CENTENNIAL ST.
87-V-3

PEAKS ISLAND

CITY OF PORTLAND

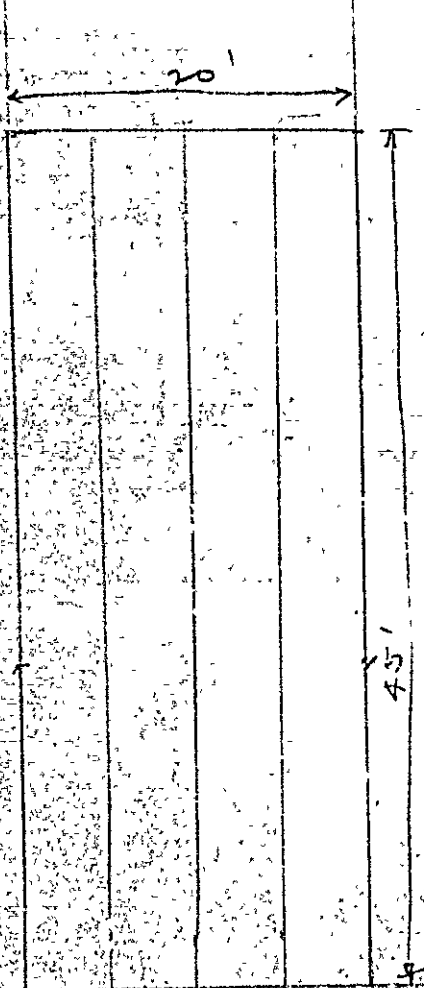
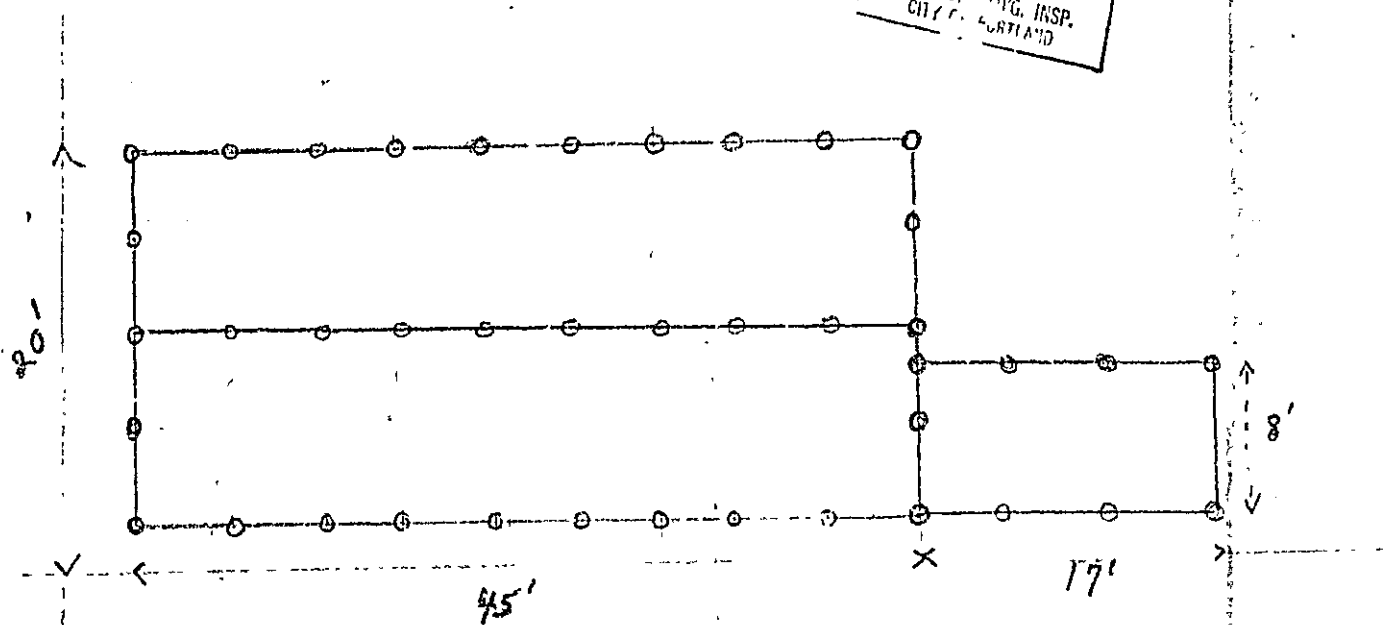
Referring to the above subject, the 4x6 sills to be used beneath the doubled
2x4 sills should be set with the 6-inch dimension upright and the cedar posts under
the side walls of the cottage should not be spaced more than 5' from center to center.

Under the end walls of the cottage there will of course be cedar posts under
the corners and one under each end of each of the three longitudinal 4x6 girders which
you have shown on your plan, thus making the two corner posts on each end and three
intermediate posts.

On the basis that the three lines of 4x6 girders or beams under the interior
of the cottage are set with the 6-inch dimension upright to get the 24-inch spacing
then as beams, the cedar posts under these girders ought not to be spaced more than 5'
from center to center. These 4x6 girders may be spliced two or three times in the
length of each, and of course a post would have to be put directly under the splice
in each case even if that made them come somewhat closer together than 5'. I do not
know that it is understood that all of the cedar posts will extend either to soil or to
beneath the cottage or to a depth below the finished surface of the ground of not less than
four feet.

As I remember the framing of the first floor as far as I could see it from the
outside, the 4x6 beams running the length of the cottage are uniformly spaced and prob-
ably then are about 5' from center to center, since the cottage is 20' wide. On this
basis if the present 2x4 floor joists are set with the 4-inch dimension upright, we
would not expect them to be strengthened at all, provided they are in good condition
and provided there are not some loads of partitions or otherwise above that we do not
know about. About the only discrepancy is that they are 24" from center to center,
whereas if the building were being built now, the Building Code would require them to
be no more than 18" from center to center. The fact that makes them satisfactory is
that they run such short spans, the 4x6's being so close together.

At present the sills are 2 x 4's, doubled. We propose to put 4 x 6 sills all the way around under present sills.

Girders are all 4 x 6, full length of the building.

For about two-thirds the length of the building there are 2 x 6 floor timbers, 16" o.c., the balance 2 x 4, 24" o. c. Would you advise that we double up on the 2 x 4 floor timbers?

What distance o. c. would you suggest that we put the cedar posts?

4x6 rills

load per lin. ft.

$$\begin{array}{r}
 36 \times 10 = 350 \\
 45 \times 2.5 = 113 \\
 10 \times 10 = 100 \\
 \hline
 563
 \end{array}$$

$$OK \ 4 \times 6 \text{ on } 7 \text{ ft span} = 2815$$

$$4 \times 6 \text{ on } 9 \text{ ft span} = 157$$

Plan for proposed cottages for Brackett Memorial Methodist Church, permit for which was applied for August 21, 1947 by Alonzo Foss, Peake Island, Maine.

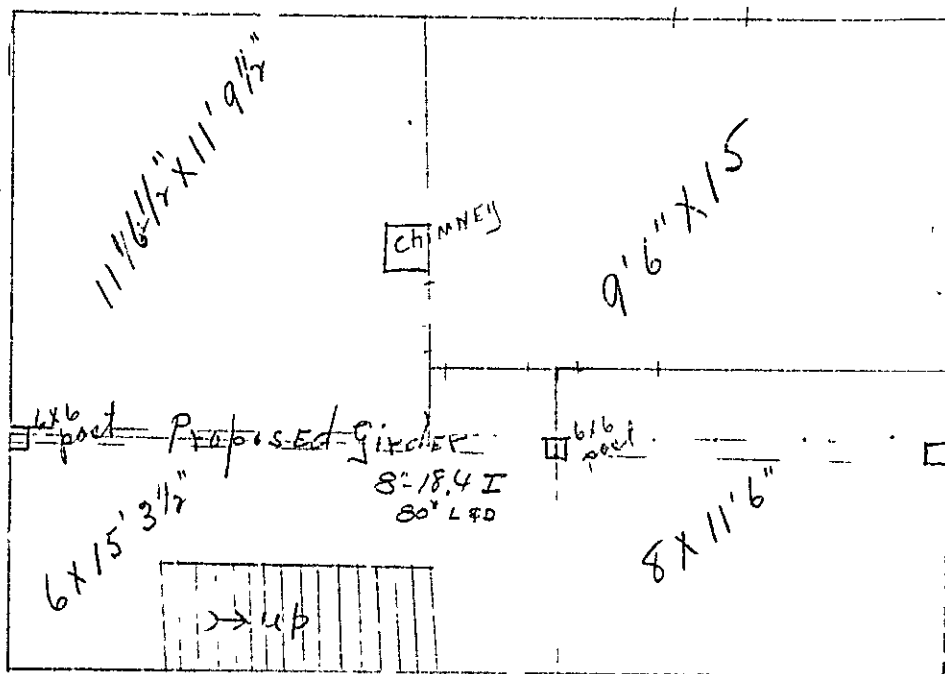
It is necessary to exclude the construction of the proposed 6' x 17' addition until information as to framing, foundations etc. has been filed with application for amendment to this permit. No location on the Blackman property has been shown other than the fact that the building would be 10' from side line. Apparently the Blackman lot is a very large one and you probably will not go wrong on the location but the zoning law requires not only 10' from each side line, but also 20' from the rear line.

I have looked the building over on the outside but could not get inside. It is my recollection that most of the floor joists are only 2x4's, running across the building, and that they are supported at two or three points in the width of the building by 4x6 beams, running the length of the building and set with the 6" dimension upright. If that is the case the single line of cedar posts shown on the sketch through the center of the building would not be enough as each line of 4x6's should be similarly supported, but perhaps the posts need not be so close together.

Cedar posts under outside walls are shown about 5' from center to center, which is probably sufficient under the side walls if the sills are 4x6, set with the 6" dimension upright, or heavier timber.

The permit is issued then on the basis that the cottage will be supported in adequate fashion, depending upon its present framing. We shall be glad to help out in this connection, if we can be shown on a plan just what that framing is.

Memorandum from Department of Building Inspection, Portland, Maine
Centennial St. - Peaks Isld. (Albert L. Thompson, Owner) Alterations in Dwelling House
by Fred Stephenson, Builder—4/9/46

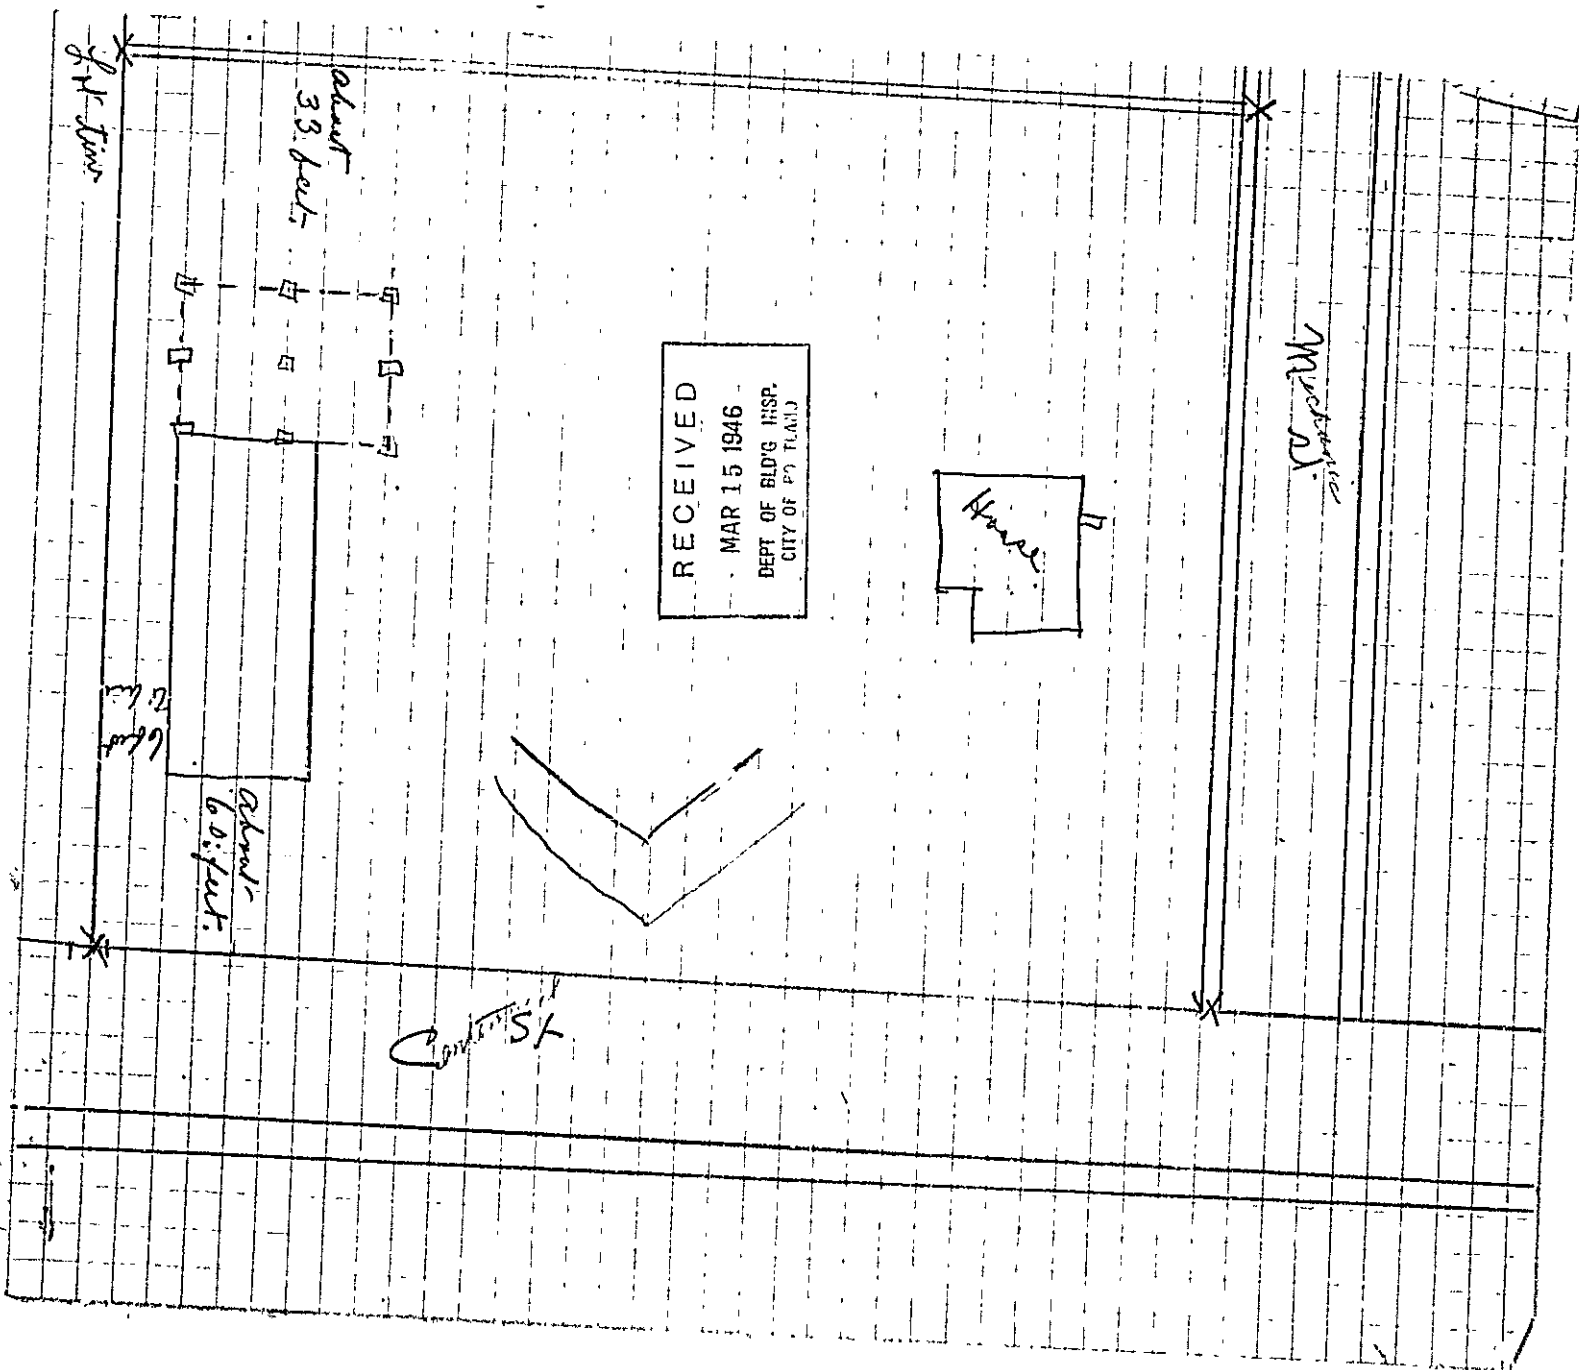
The plan is not very clear as to what is intended, and is especially lacking in showing proper supports down to the ground for the 6x6 posts indicated to support the new steel beam.

Therefore the contractor will have to assume responsibility for compliance in that particular.

Addition to garage for storage

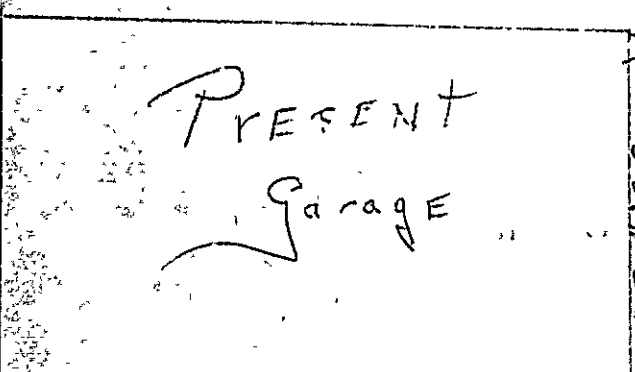
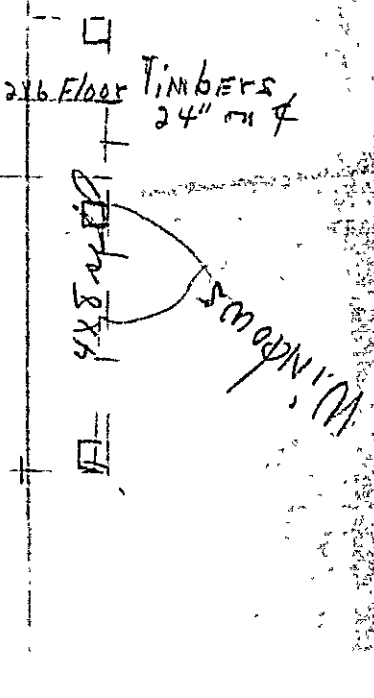
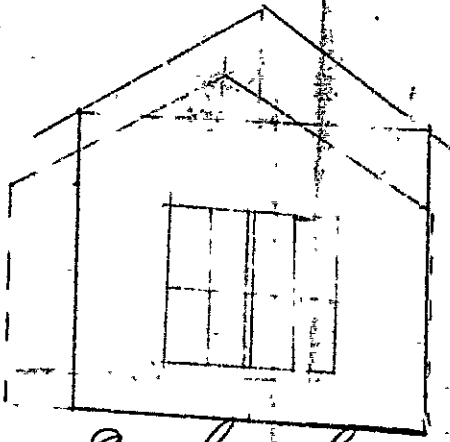
In an effort to avoid correspondence and delay on this small job I called Mr. Stephenson and straightened several questionable matters. There is to be concrete over the wood floor, this being a more quiet rate as it is near the water.

Structurally it was not correct and mashed over sills are by me after my conversation with Mr. Stephenson.

Outside sill 4x8 on edge on 6" span 4153#

Center sill 6x6x100 = 3600 # O.K.

Floor joint 2x6 on 6" span 1047#

Prof 2x8 on 12" span 931

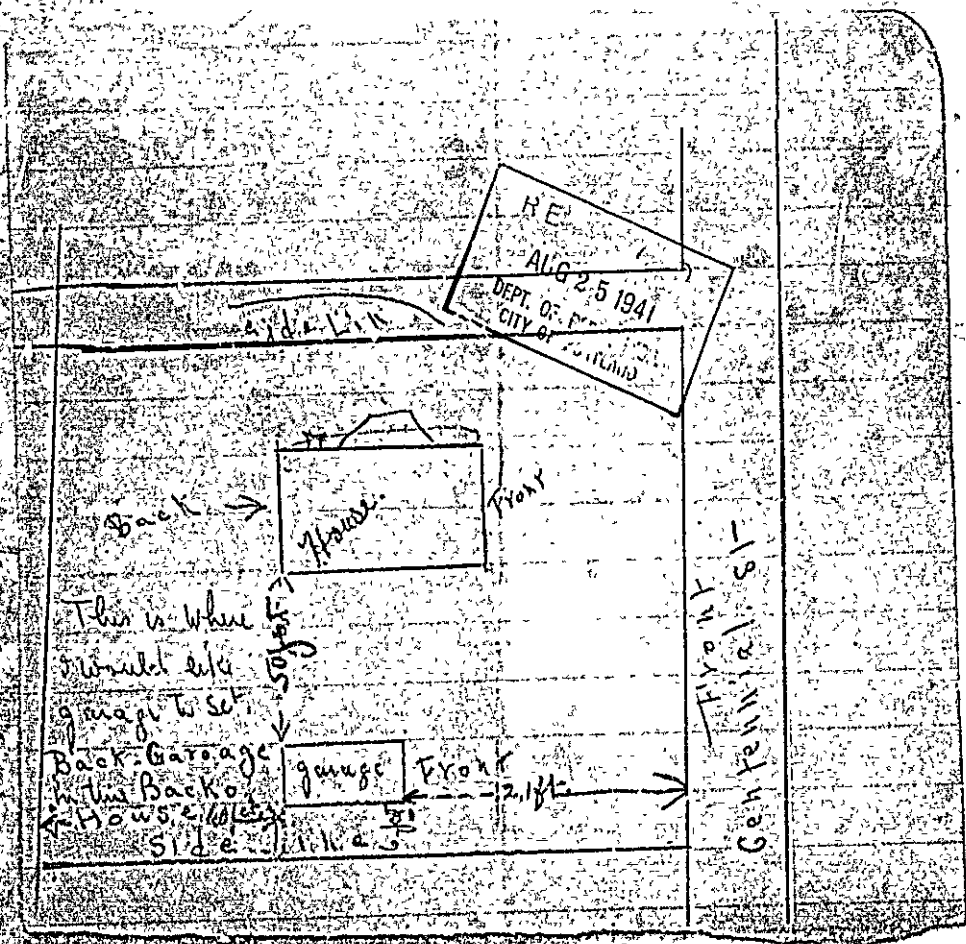
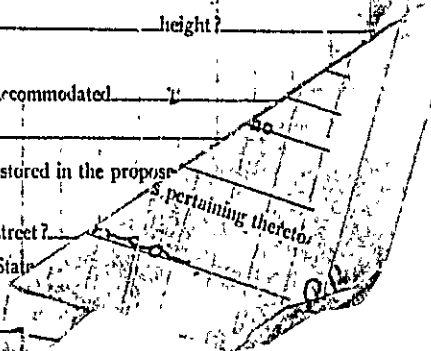
Some person has seen fit to move the garage from Oakland Avenue to Centennial Street, Peaks Island, although we have not yet been able to issue the building permit since the location has not properly staked out and checked. On September 5th, however, the building had not been moved to the precise location on the lot on Centennial Street indicated on your location plan filed with the application for the permit. As it stood on that date the front of it was only 13 feet from the street line of Centennial Street thus bringing the front wall closer to the street line of Centennial Street by about two feet than the front wall of the house on the next lot, the zoning law requiring that the front of the garage be at least as far from Centennial Street as such a front wall of the house on the next lot. Our inspector says that as located on September 5th, there was four feet between the rear wall of the garage and the rear property line. Thus, it would seem that you have room enough to move the garage back two feet and thus line it up with the front wall of the house on the next lot.

The Building Code provides, however, that the overhang of the eaves of the building is not permitted to be closer than two feet to the rear property line.

There is a note on the back of your plan which says that you are to support the building on 6x6 timbers laid flat on the ground until such time as you can put a concrete foundation under the garage. The application says properly that you are to support the building on flat rocks. It is not allowable to merely rest the 6x6's on the ground but it will be satisfactory if you rest them upon flat rocks at frequent intervals or even on so-called "mud-sills" which are really heavy pieces of lumber laid on the ground and then the 6x6's rested on them. Perhaps I do not understand what you intend to do but the object of the law is to prevent the main sills of the building being down in contact with the ground where they are likely to rot.

If this can be accomplished, now that the garage has been moved as far as it has without a permit, it will be necessary for you to move it to its correct legal location, then notify this office for checking, whereupon if the location seems to be a legal one we will issue the related permit.

It will be necessary to fill out all of the blank on the sheet attached and return to this office, also to stake out the proposed location of the garage on the ground and also see to it that the property lines nearby the proposed garage location are clearly marked so that an inspector from this office may check the location against your plan on the ground.
